INDESIT company

Model type:
MB40D2NFBSSP

Commercial code:
F029784

51522e0 Exploded views

NT007600

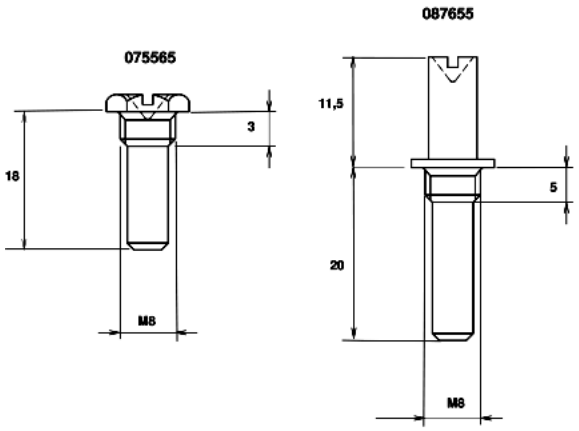
From the month of February 2002 (reg. No. 20207.0001) the Melano production has modified, on the electronic Ariston-2001 combinations with the display, the pivot of the hinge because the latter interfered with the wiring, which is lodged in the superior hinge, causing the breakage of the internal filament. Consequently, when it is necessary to substitute the wiring (081844) on the pre-modified models it will be also be necessary to change the pivot of the superior hinge with the new (see figure NT007500). When reassembling the wiring (081844) pay attention that it does not get trodden by the hinge and that it will be positioned around the pivot leaving it soft and not rigid (see figure NT007600).

087655 - SUPERIOR PIVOT HINGE M8X5 (H=20+11,5)

075565 - SUPERIOR PIVOT HINGE M8X3 (18+2,5)

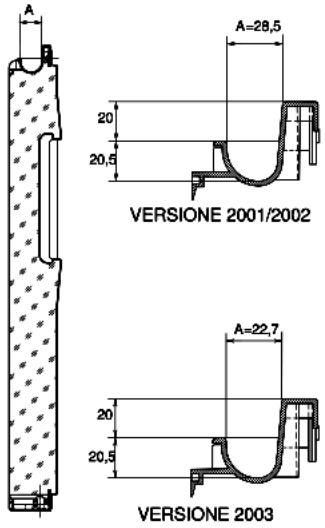
In March 2003 the Melano factory started using freezer doors with modified handle on the Ariston Opera-60 combined fridge-freezers (models MB-MBA-MBAA), in order to eliminate the problem of condensation.
The grip width has been reduced (from 28.5 to 22.7 mm) on these doors, as indicated by the dimension (A) in the figure (N1030059FIG1).
These freezer doors are already available as replacements and a coloured label on the packing distinguishes them from the previous ones. This will be done until stocks of premodification doors run out.
The codes of the freezer doors have not been changed:

New parts

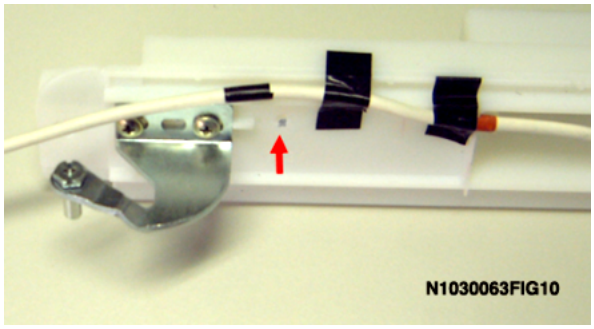
In October 2003 (serial no. 31028.0001) the Melano factory replaced the upper plastic hinge assembly on the Opera-60 fridge-freezers with display, in order to improve the fridge door support and prevent the cable connecting the two cards (power and display) from being damaged.
The new assembly provides for use of the upper hinge, chromed, with relative pin, and modified hinge cover (see fig.1-2).
The hinge assembly is reversible by rotating the single parts 180° and then refitting the pin (see fig.3).
Another two other tape reference marks (now three) have been placed on the card connection cable for correct installation on the panel base and fridge door in order to have the right flexibility during rotation. When the door is open the cable must never be strained.
The reference marks on the cable refer to right hand opening (see fig.4):
-Reference mark (A) indicates which end must be connected to the panel power card.

081644 - UPPER HINGE(M8) RH-LH CHROMED
075565 - UPPER HINGE PIN M8X3 (18+2.5)
097861 - UPPER HINGE COVER RH-LH ALUMINIUM
097862 - UPPER HINGE COVER RH-LH WHITE

097872 - PANEL/DISPLAY WIRING (3-MARKS)

081846 - UPPER HINGE (M8) RH WHITE (WIRING)
081847 - UPPER HINGE (M8) LH WHITE (WIRING)
081844 - PANEL WIRING (DISPLAY) KIT
081848 - UPPER HINGE COVER WHITE
082013 - UPPER HINGE COVER ALUMINIUM-METAL

N1030063FIG4

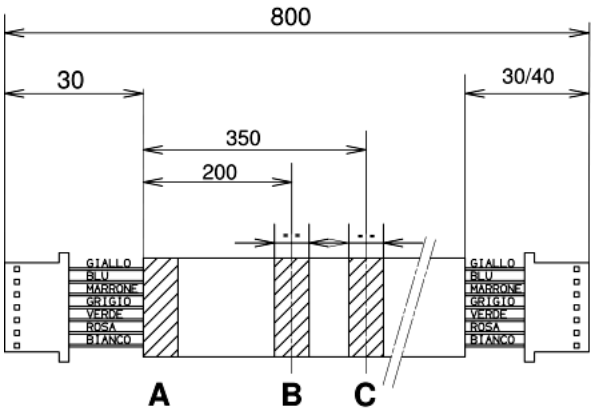
-Reference mark (B) must be fitted in the seat obtained on the panel base (see fig.5).
-Reference mark (C) must be fitted in the seat obtained on the right side of the door, in the hinge area (see fig.6).

N1030063FIG7

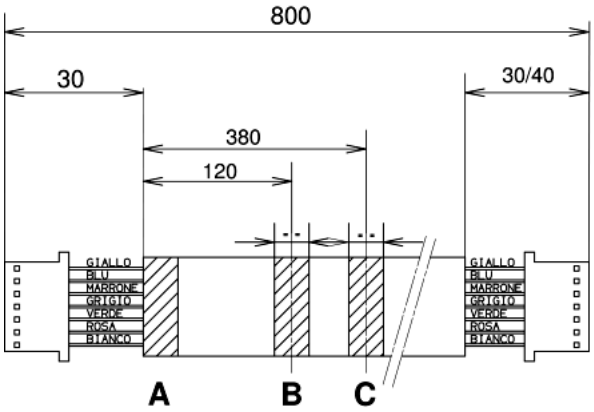
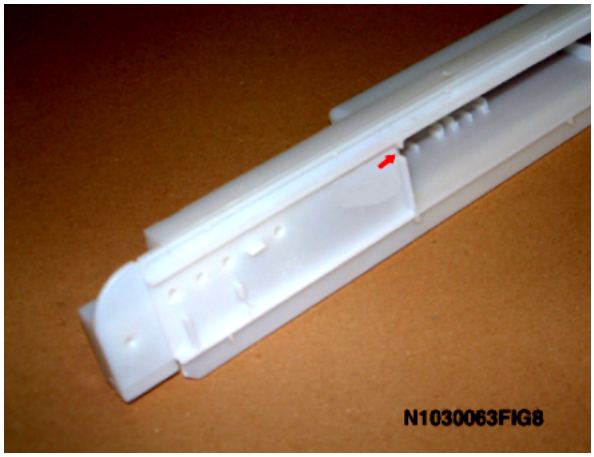
If the door opens on the left, these reference marks on the cable must be modified as shown in fig.7.
(A) has not been changed, whereas (B) has become 120 mm and (C) 380 mm. Colours other than black can be used so as not to confuse them.
Also, reference mark (B) must be fitted in the seat obtained on the panel (see fig.8), whereas the (C) must be fixed in the second tab from the left (see fig.9).
In the left-hand opening version, when tightening the fixing screw make sure the cable is not crushed by the panel. To avoid this, the cable should be fixed with adhesive tape to the vertical and horizontal ribbing, so that it passes inside the groove, thus avoiding the hole (see fig.10).

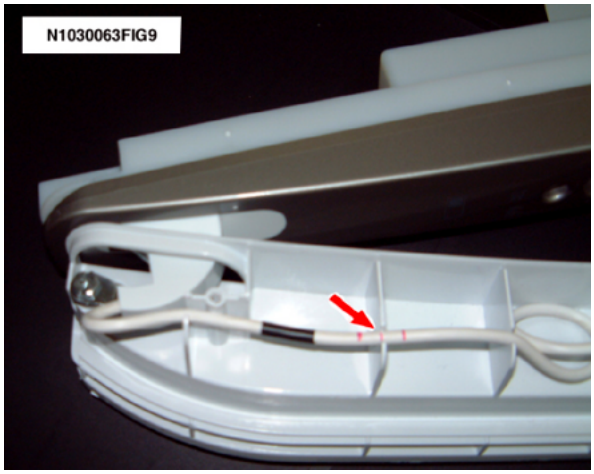
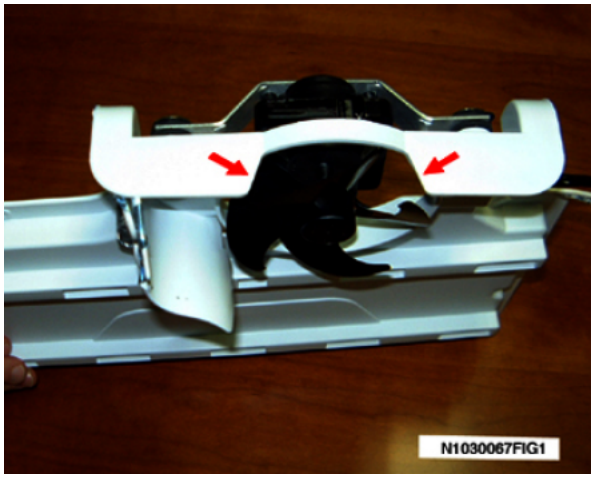
On Ariston and Indesit Opera60 Total No Frost fridge-freezers produced before August 2003, the freezer fan may stop due to ice

build-up (stalactites), activating the alarm.
The problem has been solved by emptying the conveyor (chamber separator) in the upper part to give the fan more space (see fig.1).

To solve the problem in products in use, an air conveyor kit (Sat code 094490), which also includes modifications to reduce dispersion air flow, has been introduced since 25/9/2003 (see fig.2) and 06/10/2003 (see fig.3).

KIT 094675 N1030068FIG3

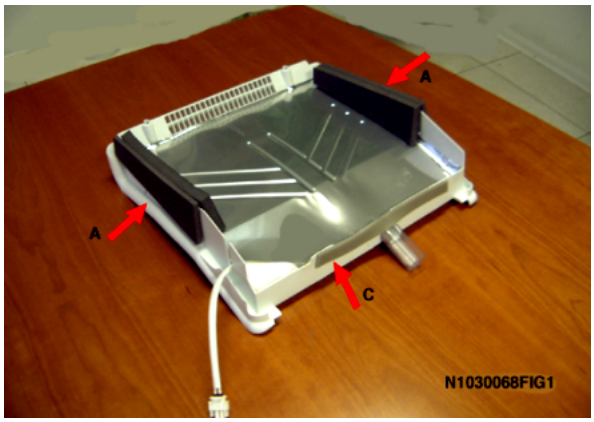
2) The lower vents on the multiflow have been closed from the inside (see fig.3/4-ref.A) and the outlet of those located in the curved area has been reduced (see fig3/4- ref.B). To solve the problem on products in use there are two spare part kits: 094675 for the version with three outlets, and 094737 for that with four.

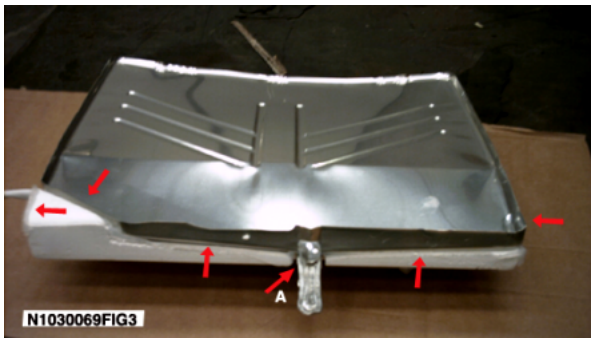
The problem has been solved by fitting a double filament resistance at the end part, which can be seen by removing the rubber protection. (see fig. 1). The resistance is glued to the drip (see fig. 2).
Freezer separator Sat code 094485, complete with modified resistance, is managed as a replacement to solve the problem on products in use.

If the 40W resistance needs replacing it will be necessary to restore the sealing, located in the hole area, using silicone (see fig3 - ref A).
Also, to protect the separator from possible water penetration, silicone is used to protect the drip with polystyrene insulation at the back, and also the right corner, relevant to the wiring outlet is protected with silicone in the upper part.

N1030079FIG2

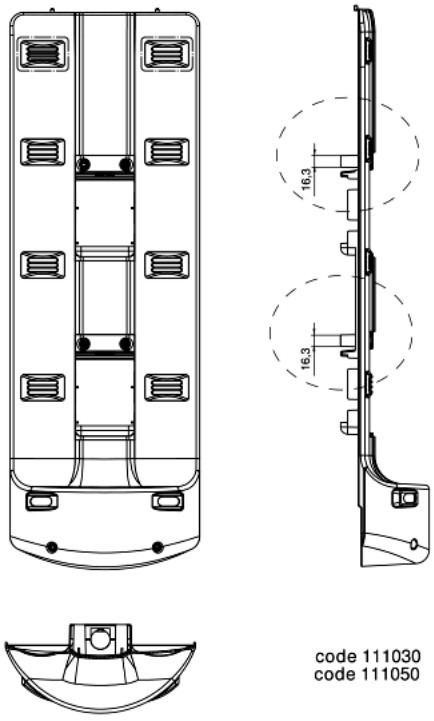
In June 2004 (serial no. 40604.0001), the Melano factory modified the multiflow fixing system to the shell on Ariston and Indesit Opera-60 Total No Frost fridge-freezers.
The inner wall of premodification models featured four square marks (20x20) in the central area for fixing the multiflow cover. The four marks have been eliminated and the wall only features the position for the holes.
Furthermore, the head of the four pins that house the fixing screws on the multiflow cover have been modified. Premodification items ended with an external diameter of 9 mm, whereas the current version has a diameter of 16.3 mm (see figures N1030079FIG1 and FIG2).
The new multiflow cover can be mounted on premodification models but not vice versa, paying attention not to overtighten the screws as the pins may break. If necessary, bush 039567 can be used as stopper.
The multiflow cover is managed as Kit to solve the problem, on products in use, of the formation of condensation on the vegetable basket due to the inflow of cold air from the freezer (see note N1030068).

111030 - 4-way multiflow cover KIT (serial no. 40604.0001)

111050 - 3-way multiflow cover KIT (serial no. 40717.0001).

094737 - 4-way multiflow cover KIT
094675 - 3-way multiflow cover KIT

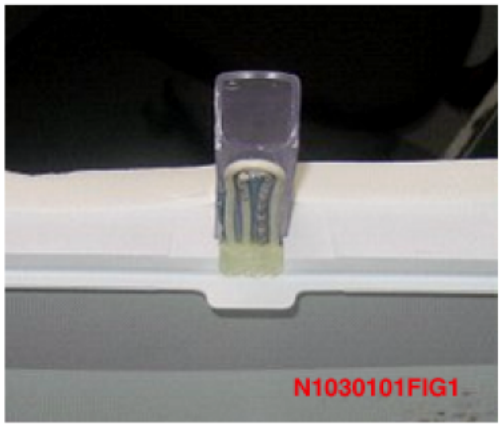
In October 2004, the Melano factory modified the freezer evaporator and return tube on Ariston and Indesit Opera-60 total no frost fridge-freezers, in order to improve the connection.
Now the return tube is straight (outer diameter 6 mm), whereas previously it had a socket end 15 mm long (outer diameter 6.35 mm).
Before the modification, the coil tube on the freezer evaporator (outer diameter 8 mm) was straight, now it has a tapered end section 15 mm long (outer diameter 7.6 / inner 6.2 mm) to insert the return tube.
If the evaporator needs replacing, it will be necessary to connect it with a Lokring connector 7.5/6 NRAL50 (058213) or 7.5/6NRMS00 (058203).

If tightness is lost when the ring is removed, it will be necessary to use connector 8/6 NRAL50 (058214) or 8/6 NRNS00 (042050).

The new freezer evaportor can be fitted on premodification appliances, but once the ring is removed, the 6 mm outer diameter must be restored on the return tube (check that it is long enough to be able to use the pliers to connect the 7.5/6 ring).

113845 - NOFROST FREEZER EVAPORATOR ASSEMBLY R600/R134a

094667 - NOFROST FREEZER EVAPORATOR ASSEMBLY R600/R134a
